GEORGETOWN-SCOTT COUNTY PLANNING COMMISSION

AGENDA

August 9, 2018

Staff Report to the Georgetown-Scott County Planning Commission

Figure 1

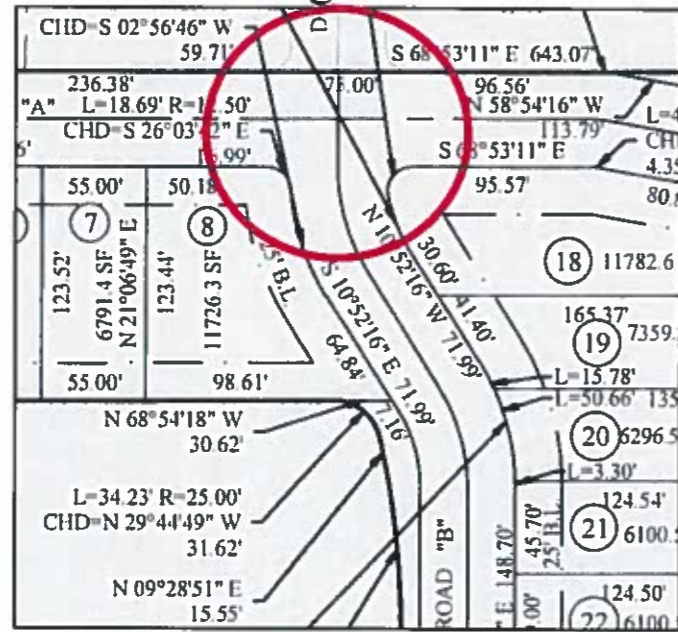
The intersection of Road "B", Road "A", and Dusk Court (see Figure 1 on the next page) requires a variance. The *Subdivision and Development Regulations* requires, "for a tangent intersection of at least 100 feet... all streets shall intersect at a desired angle 90 degrees and a minimum angle of 75 degrees." Staff supports this variance, because it allows the Applicant to align the intersection of Dusk Court and Road "B".

1. Variance to the intersection angle to allow Road "B" to align with Dusk Court.
